File FPP-1995-182  
Date 1/8/99

Location: RIO LINDA LANE & REDLANDS PKWY Project Name: VISTA DEL RIO FILING #3

**Vista Del Rio - Filing 3: Response to Final Plat/Plan Comments****Michael Drollinger****Amended Preliminary Plan**

**BUILDING SETBACKS  
VISTA DEL RIO SUBDIVISION  
FILING 3**

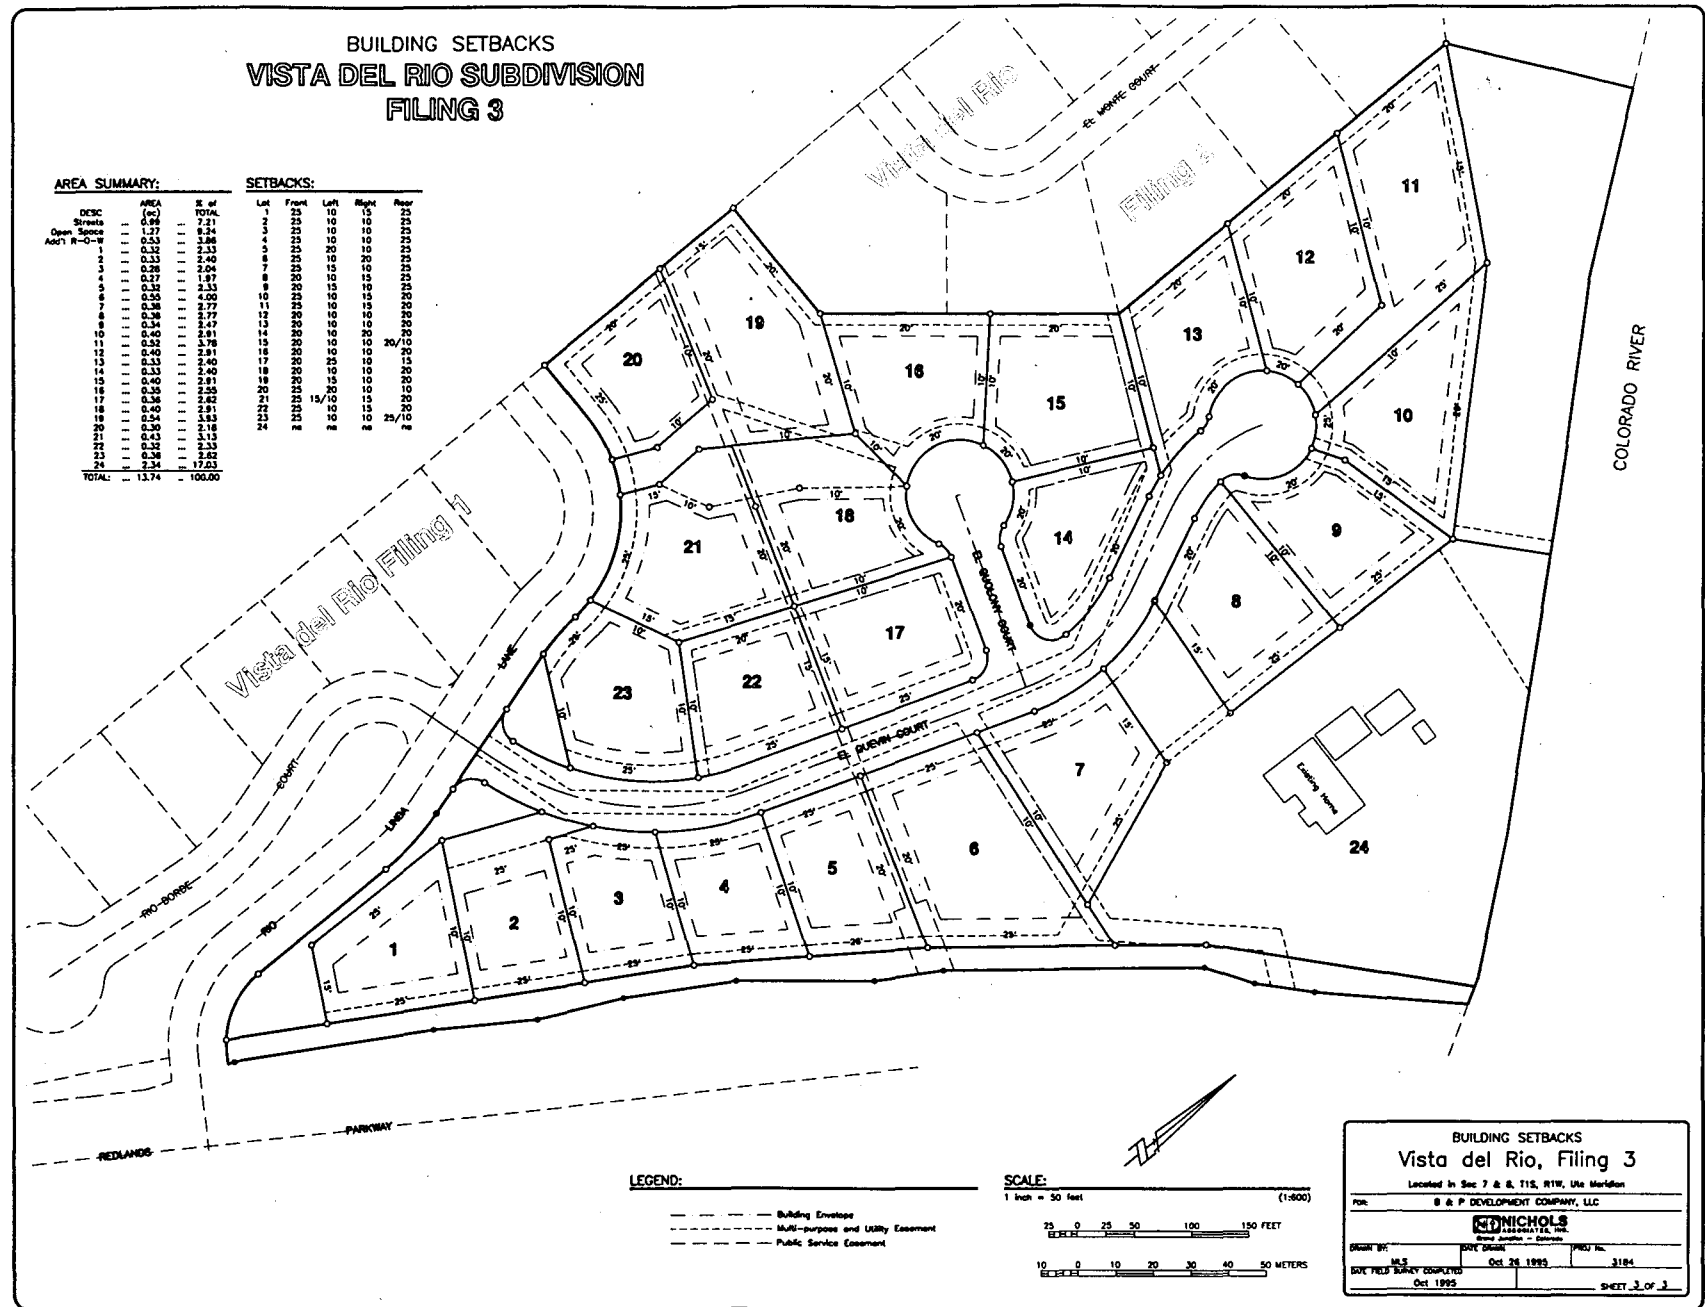
7. The Building Setbacks sheet must be modified to include a table indicating the setbacks by lot (or group of lots if setbacks are the same).

8. The legend on the Building Setbacks table is confusing - the lines are difficult to distinguish on the drawing. What is a "Multipurpose Utility and Easement"?

Table has been added to sheet.

COMPOSITE PLAN  
VISTA DEL RIO SUBDIVISION - FILING 3

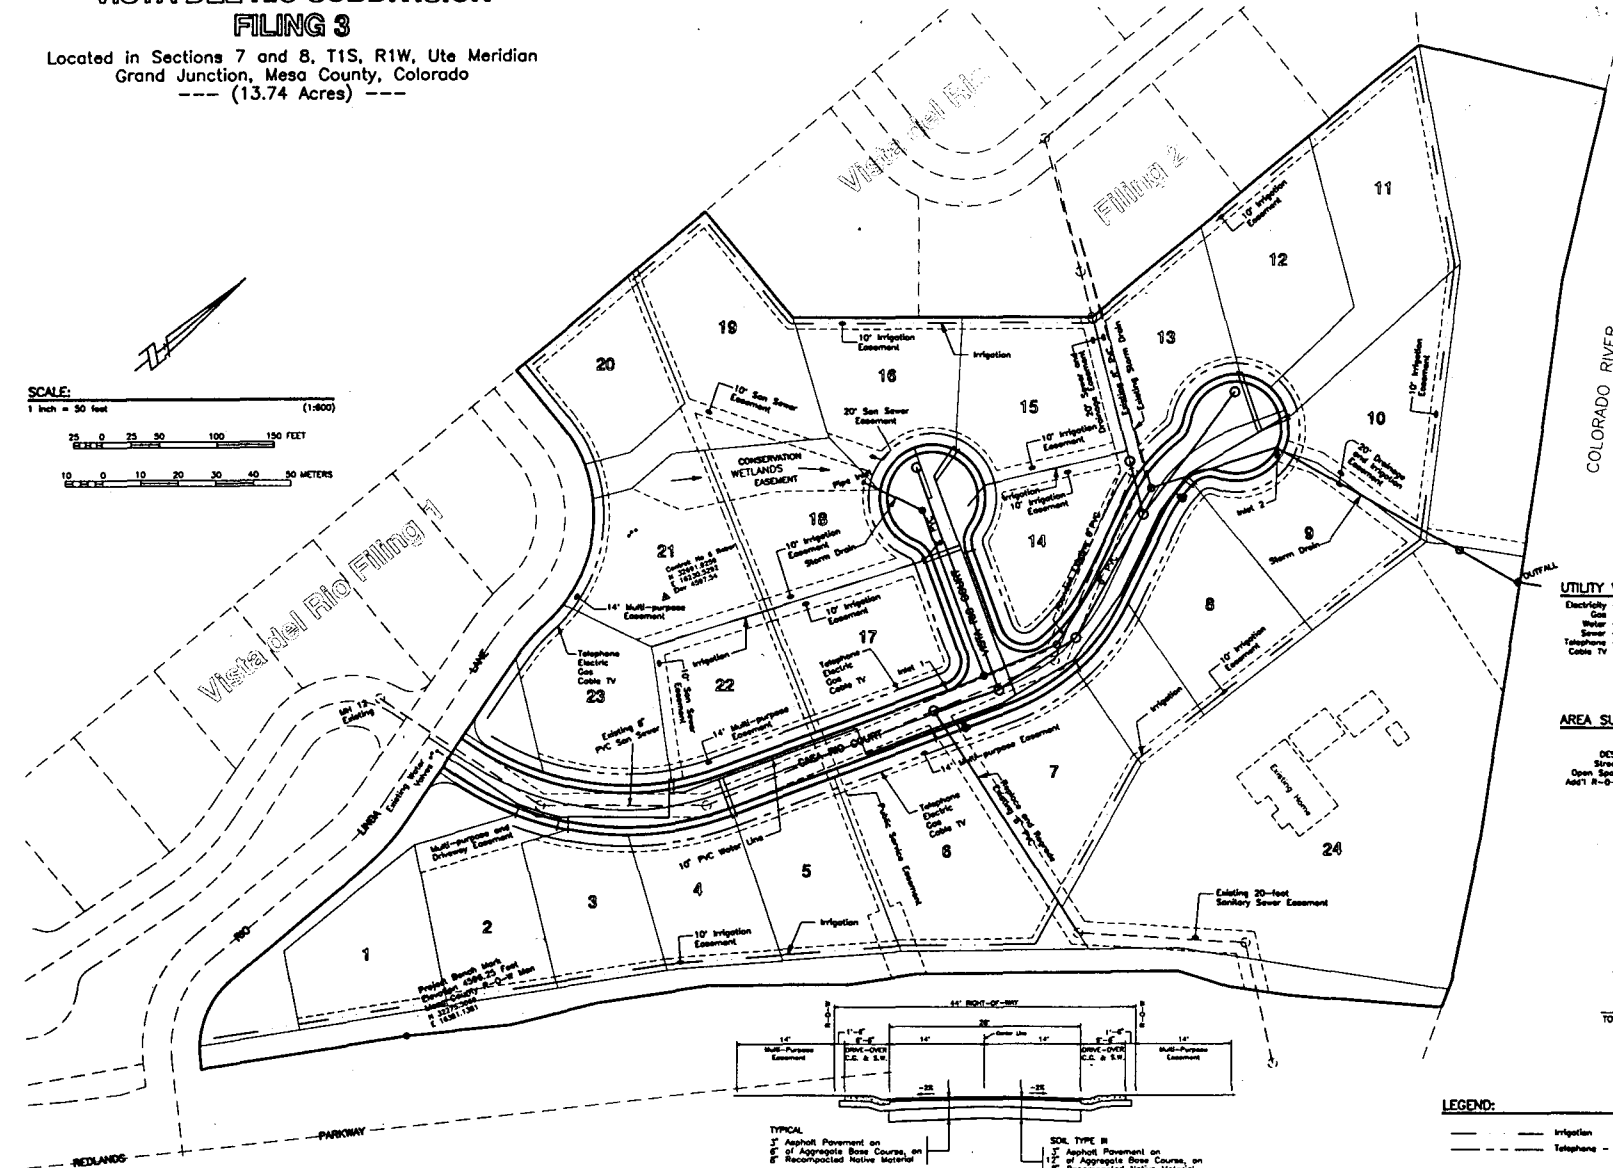
2. Composite Plan does not clearly identify easement locations, it appears that some existing/proposed utilities are outside of the proposed easements. This office will perform a complete review once these deficiencies have been corrected.

Existing Sanitary Sewer Easement Added  
Easements Annotated

Storm sewer and easement have been modified

GRADING AND STORMWATER MANAGEMENT PLAN  
 VISTA DEL RIO SUBDIVISION - FILING 3

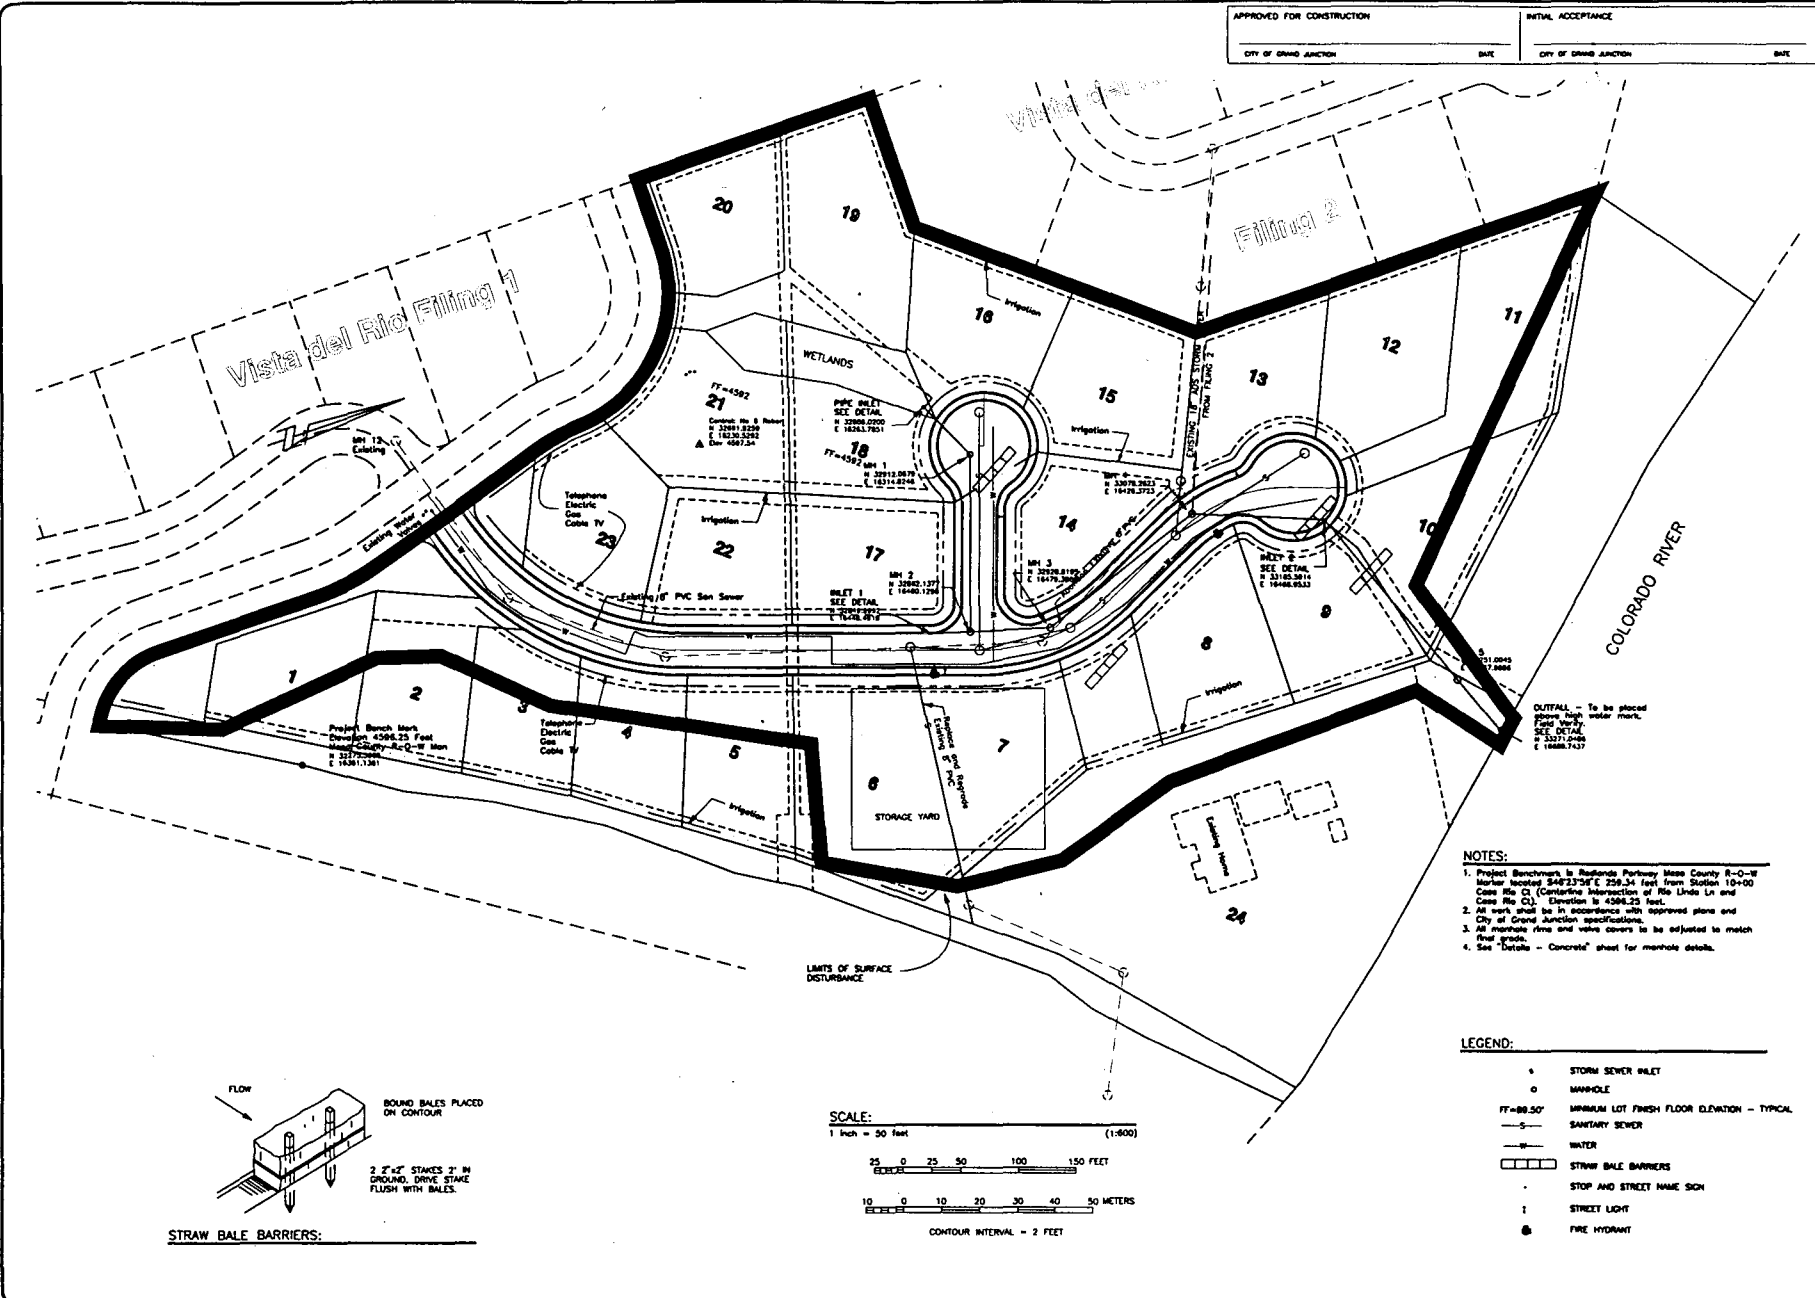
1. Need to provide contours.
2. Identify surface disturbance area - if no Colorado Dept. of Health permit has previously been acquired, one must be applied for. Section IX of SWMM contains the state regulations and phone numbers for contacts.
3. A Storm Drainage Plan and Profile is necessary - SSID IX-30. Please identify type and sizes of storm drain inlets, detail of erosion protection at pipe inlet from wetlands, outlet at outfall.

3. Grading and Drainage Plan shows no grading information; please use the SSID manual checklist to ensure that complete information is provided for review. This office will perform a complete review once these deficiencies are adequately corrected.

4. Grammatical error on Grading and Drainage Plan: detail on lower left corner should read "Straw Bale Barriers", not "Bales Barriers".

1. Need to provide contours.

3. A Storm Drainage Plan and Profile is necessary - SSID IX-30. Please identify type and sizes of storm drain inlets, detail of erosion protection at pipe inlet from wetlands, outlet at outfall.

Text revised to read "Straw Bale Barriers"

A Storm Drainage Plan and Profile Sheet has been added to the construction plans.

**WATER AND SEWER PLAN AND PROFILE**  
**VISTA DEL RIO SUBDIVISION - FILING 3**

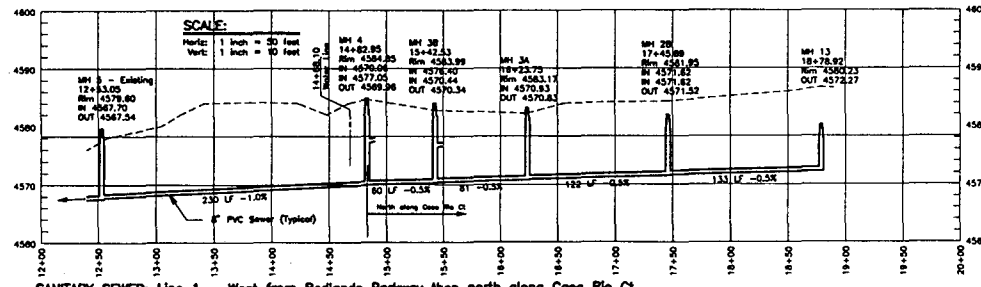
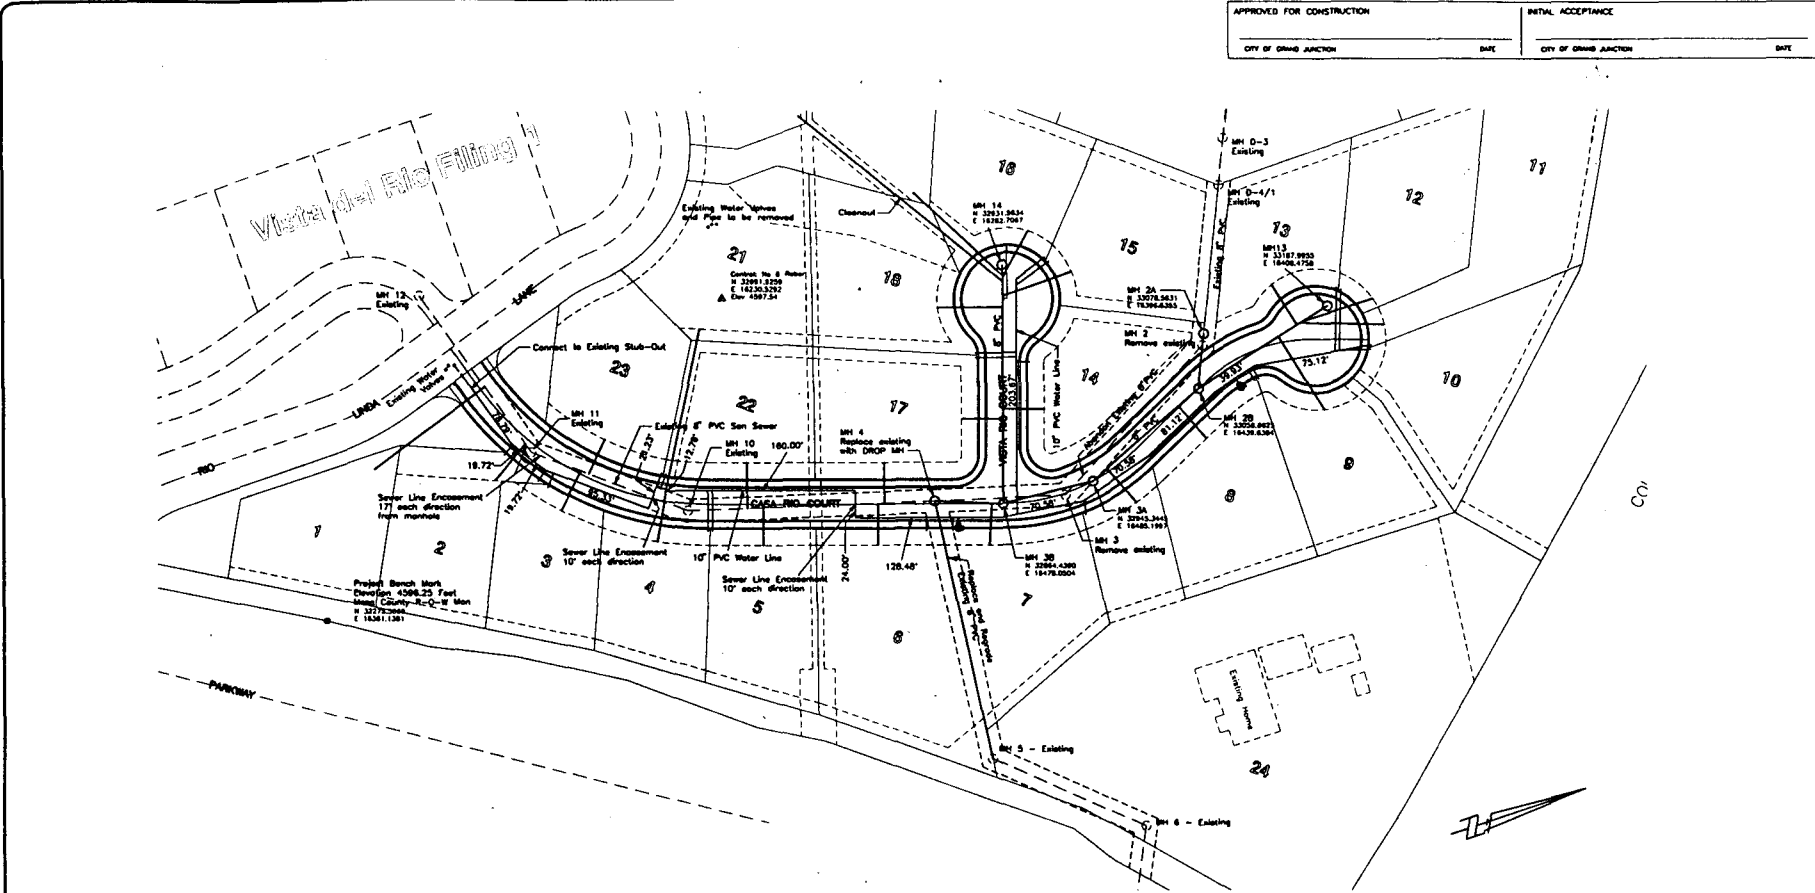
1. Easement required for sewer line between MH4 and MH5 across lots 6, 7 & 24.
2. How are existing sewer to be abandoned?
3. Construction notes referring to City Standard Drawings and Specifications are missing.
4. Sewer service line to lot 2 appears to tap centerline rather than existing sewer line.
5. Long service line to Lot 20 should have a cleanout added.
6. Show on profile where water lines intersect sewer lines such as on sewer Line 3 between MH3A and MH14. Also show special construction if needed.
7. 0.2' drop is required across manholes rather than the proposed 0.1' drop.
8. Add existing profile as required in SSID manual IX-35.
9. Please ensure all items specified in SSID manual IX-35 are adhered to.
10. No "Exhibit I" was included in the packet for review.

5. Long service line to Lot 20 should have a cleanout added.

6. Show on profile where water lines intersect sewer lines such as on sewer line 3 between MH3A and MH14. Also show special construction if needed.

8. Add existing profile as required in SSID manual IX-35.

Note added to Water and Sewer Plan sheets

Cleanout added.
